ADDENDUM

Project: Craft State Office Building 1 HVAC
– 200 South Silber Avenue, North
Platte, NE, 69101

Project No.: 23059

Addendum No.: 1

GROUND & FIRST FLOOR
PLAN - MECHANICAL

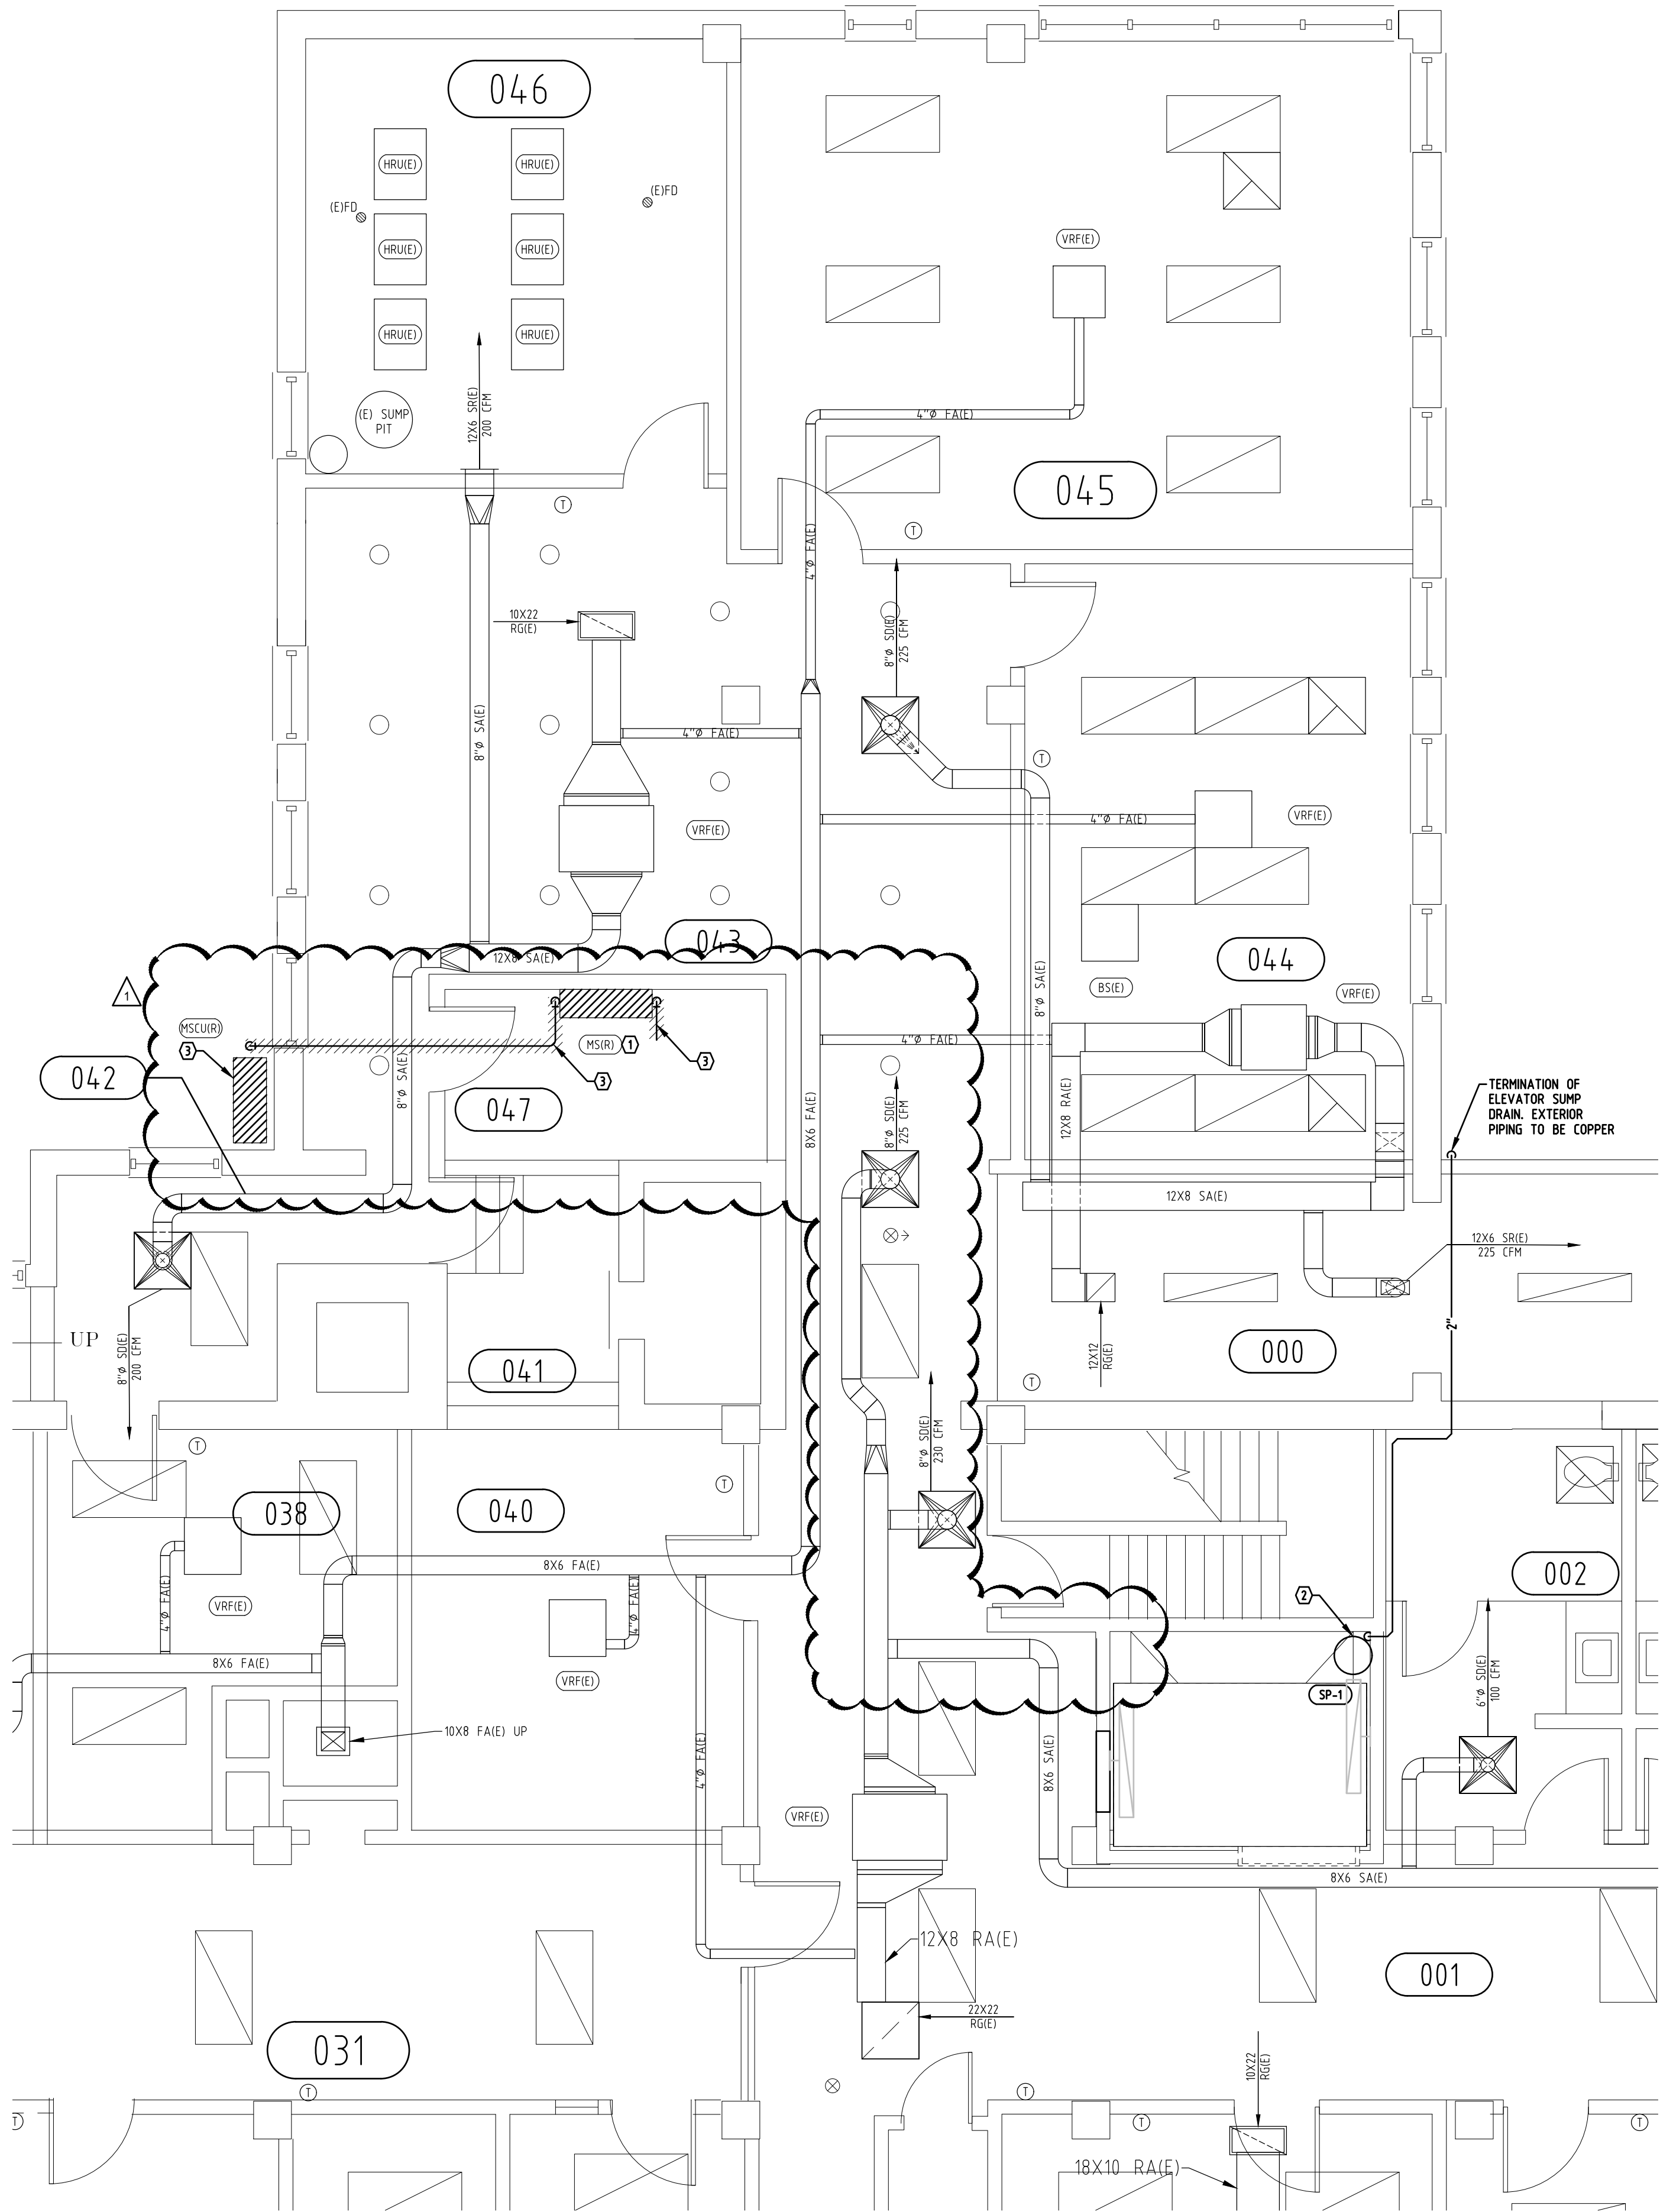
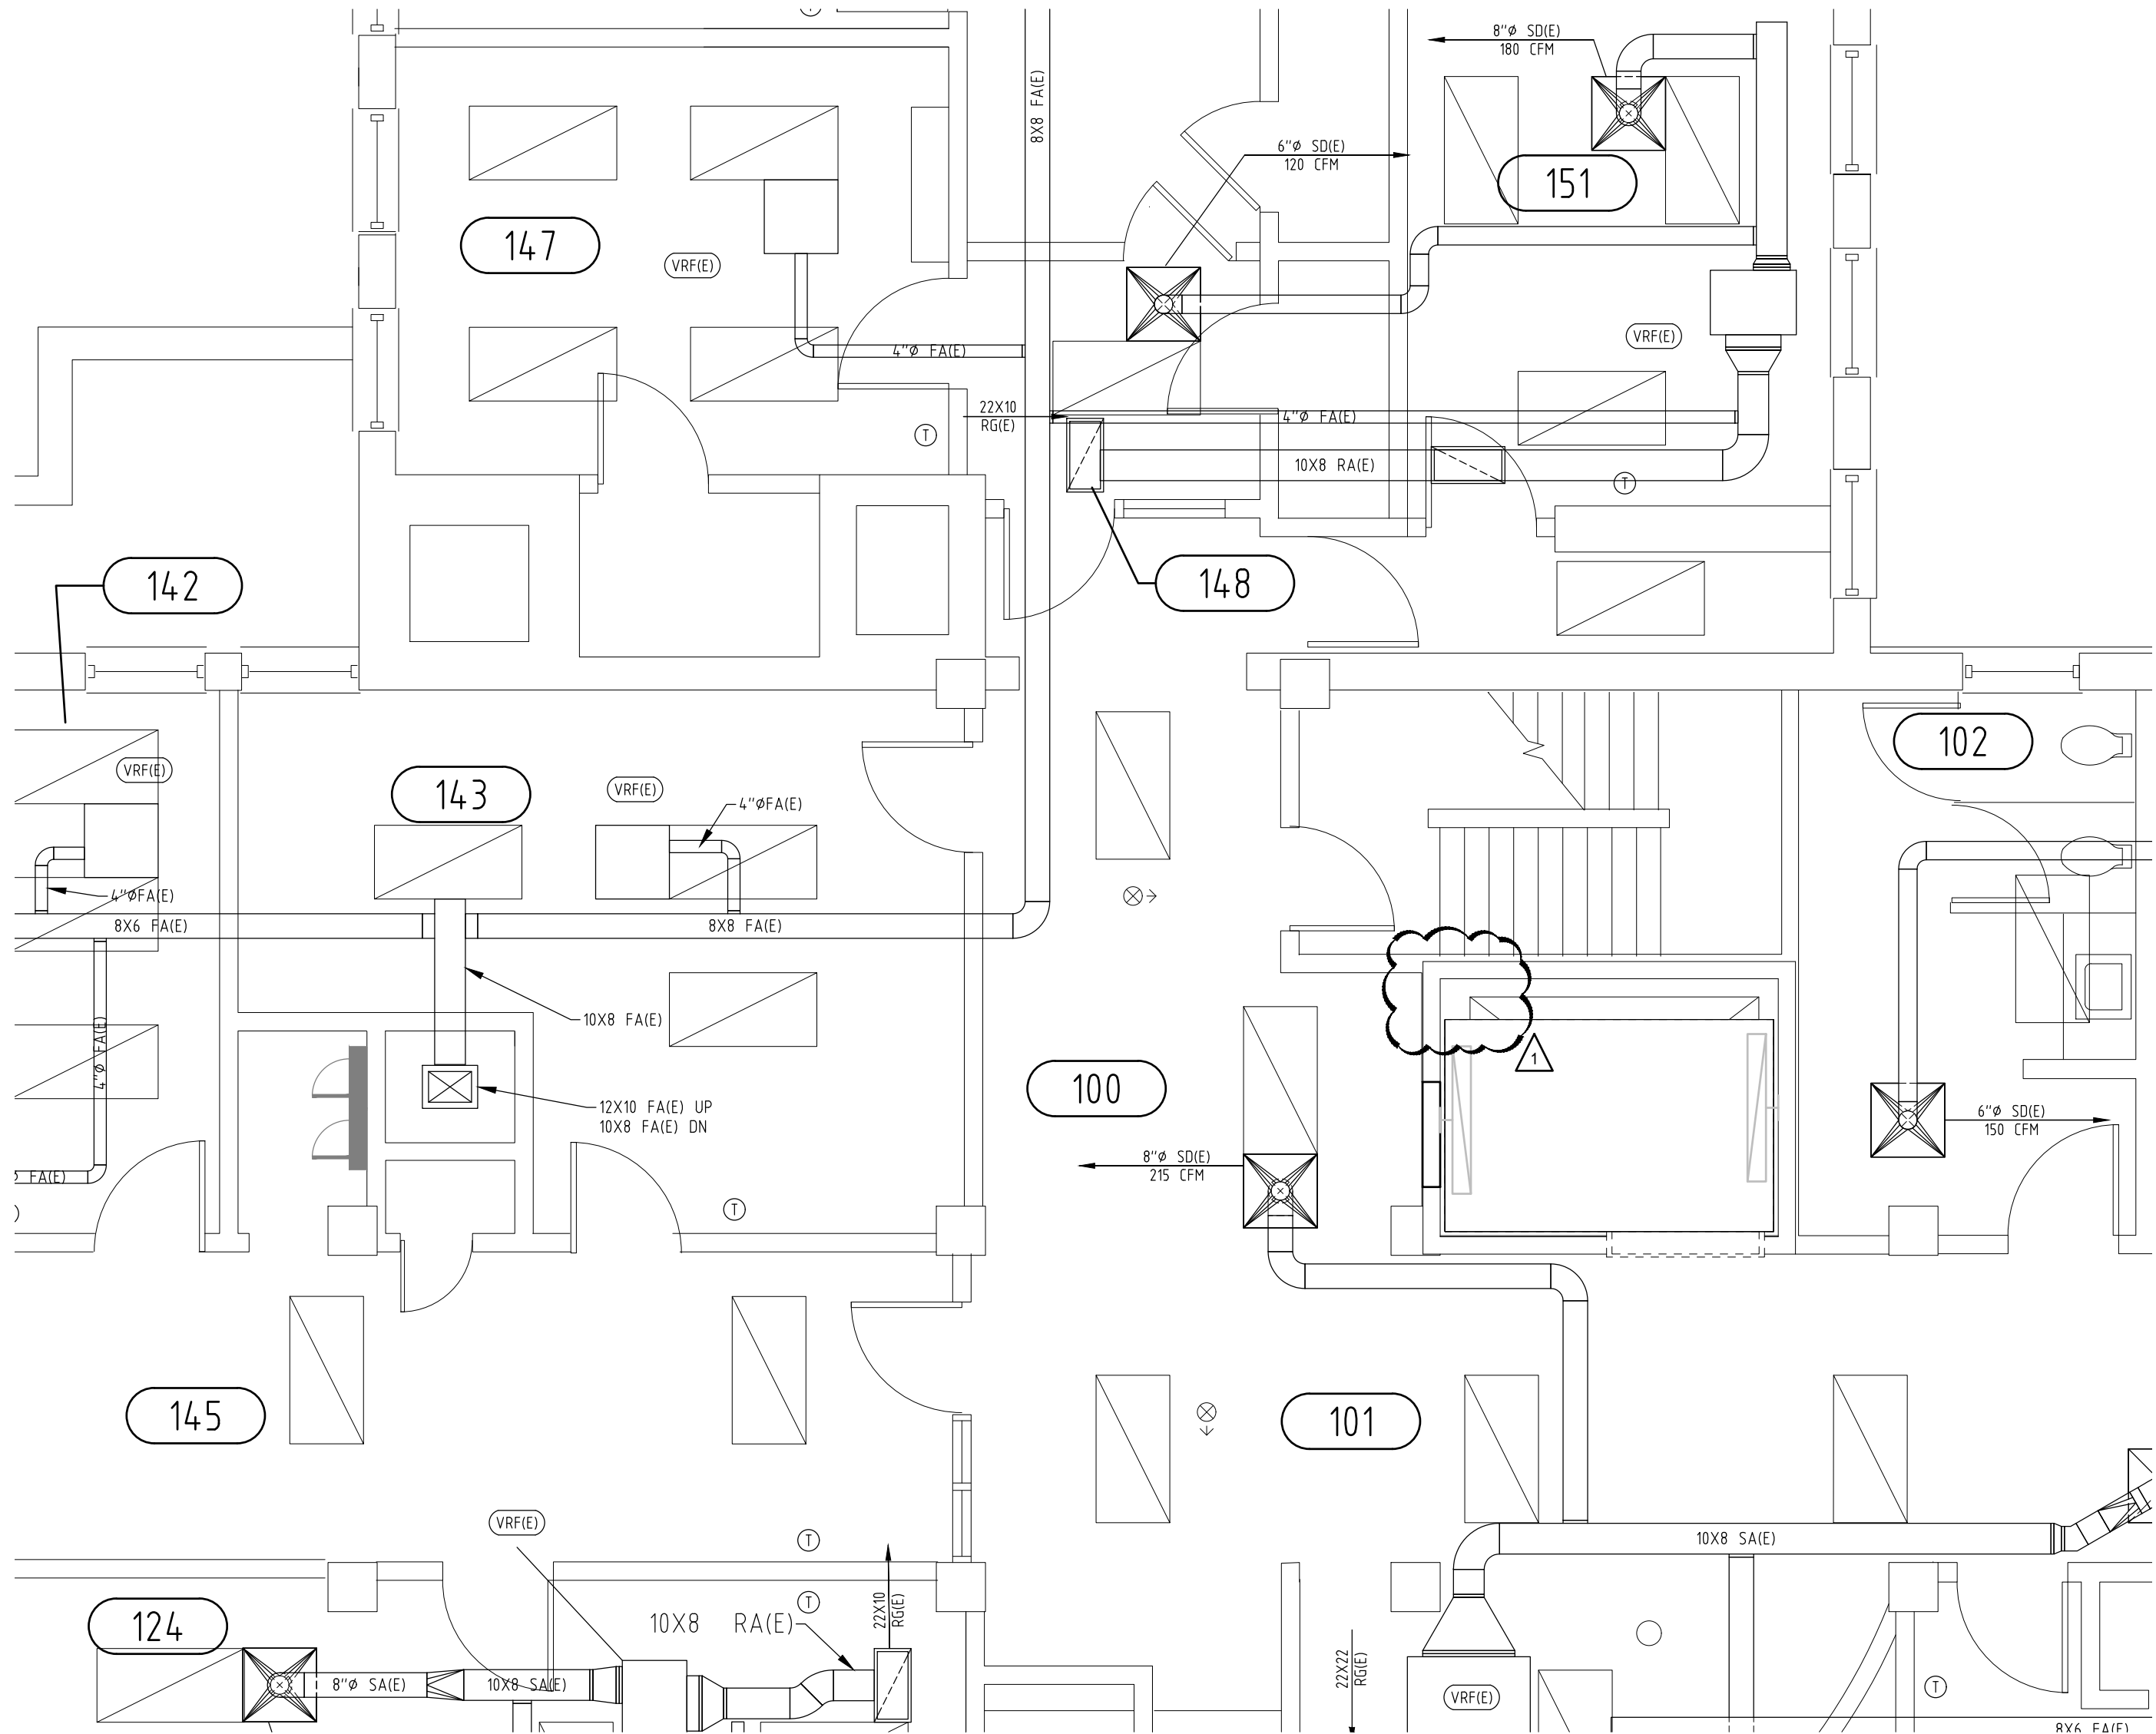
1. **T0.0 – Title Sheet**
 - a. Several notes we added to the "Overall Project Phasing Schedule."
 - b. Outlined alternative and base bid proposed by structural.
 - c. Added sheet to Structural Sheet list.
2. **M1.1 - GROUND & FIRST FLOOR PLAN - MECHANICAL**
 - a. Keynote 3 has been revised to specify relocating the (E)MSCU.
 - b. Keynote 4 has been revised to specify the removal of the existing refrigerant and humidity drain piping.
3. **M1.2 – Second and Third Floor Plan – Mechanical**
 - a. Keynote 3 has been revised to specify the addition of the Roof Hydrant.
 - b. keynote 4 has been revised to specify new location of (E)MSCU.
 - c. Keynote 5 has been revised to specify refrigerant piping from new location of (E)MS to new location of (E)MSCU.
4. **M2.1 – Details & Schedules - Mechanical**
 - a. Plumbing fixture schedule and RH-1 have been added to this sheet.

- SHEET NOTES** KEY NOTE SYMBOL = (K)
- KEY NOTES**
1. RELOCATE EXISTING MINI-SPLIT TO TOP OF ELEVATOR SHAFT. SEE 3RD FLOOR MECHANICAL PLAN FOR NEW LOCATION.
 2. EXTEND 2" DISCHARGE FROM ELEVATOR SUMP PUMP AND TERMINATE THROUGH EXTERIOR WALL.
 3. RELOCATE EXISTING MINI-SPLIT CONDENSING UNIT TO ROOF. 3RD FLOOR MECHANICAL PLAN FOR NEW LOCATION. RELOCATE CONTROLS AS REQUIRED.
 4. REMOVE EXISTING REFRIGERANT AND HUMIDITY DRAIN PIPING.
